Application Ref: NP/12/0133

Application Type	Full
Grid Ref:	SN17860820
Applicant	Mr R Lawrence
Agent	Mr P Morgan, MDA Consult Ltd
Proposal	Erection of single wind turbine with hub height of 48m & total height to tip of blades of 64.7m
Site Location	Trelessy Farm, Amroth, Narberth, Pembrokeshire, SA67 8PT
Case Officer	Liam Jones

Summary

PROPOSED SITE PLAN

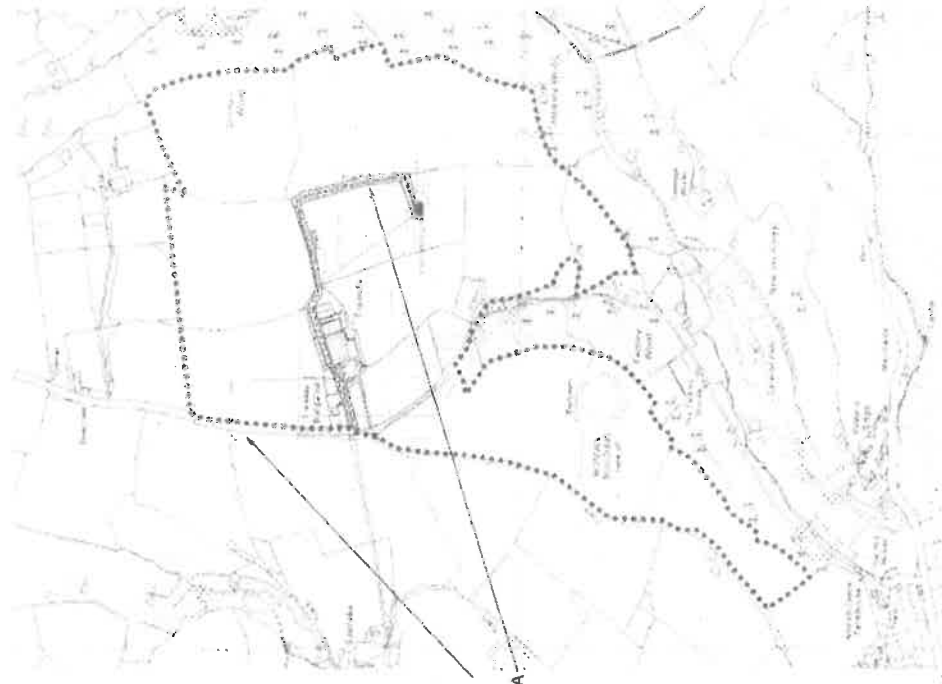
In terms of potential impact by shadow flicker from the wind turbine the applicant has supplied on plan details of the potential zone of shadow flicker from the development. Given the distance from neighbouring properties and the relative positions of direct sunlight, and the height of the turbine shadow flicker is unlikely to affect any residents.
